Reason: To clarify the fire alarm provisions and add limited technical revisions that will aid in providing clarity to the code. The general organization of the reformatted 907 section is as follows:

Approved as Modified

**FIGURE 2209.5.3
INDOOR ATTENDED FAST-FILL HYDROGEN FUEL-DISPENSING LIMITATIONS.**

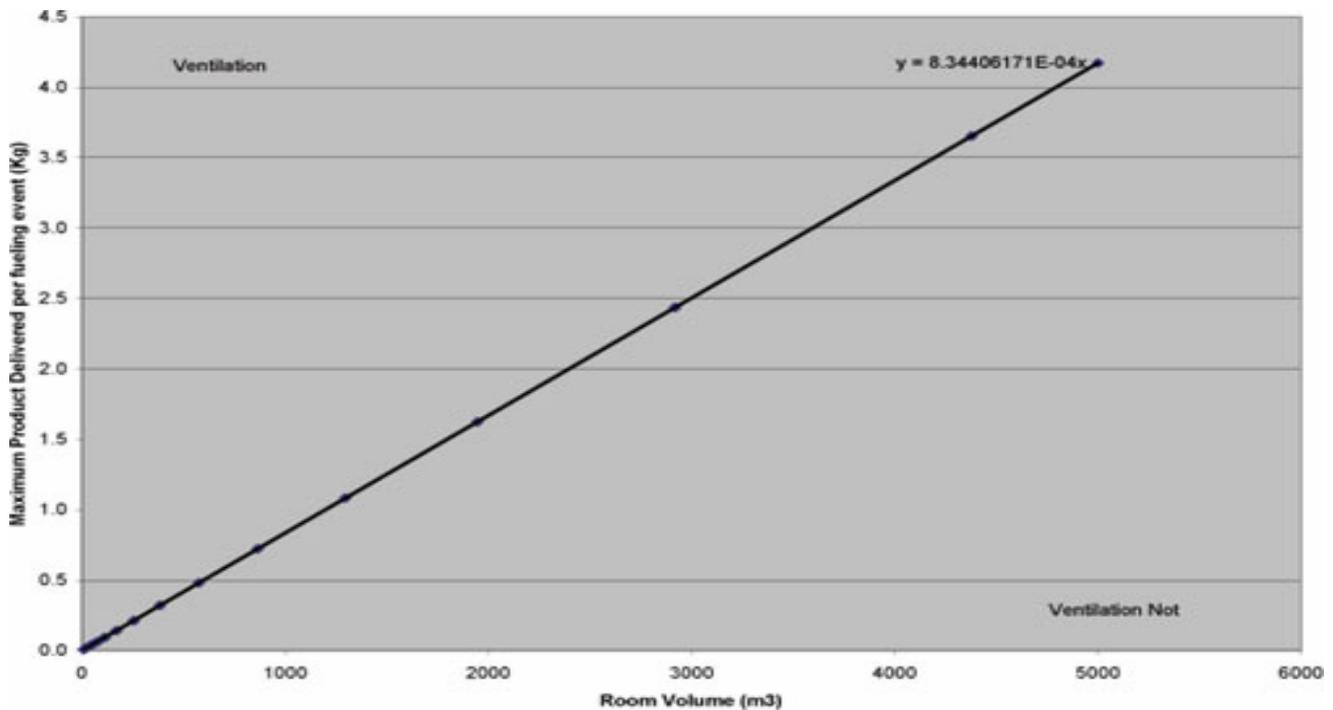
Exception: ~~Indoor attended fast-fill hydrogen fuel-dispensing areas not exceeding the space volume and maximum fuel delivery mass per refueling event as depicted in Figure 2209.5.3.~~

Exception: Indoor fast-fill hydrogen fuel-dispensing areas exceeding the room volume and maximum fuel delivery mass per refueling event as depicted in Figure 2209.5.3.1.1 shall not require room ventilation beyond that required for the location in accordance with Section 703.1 of the *International Fuel Gas Code*.
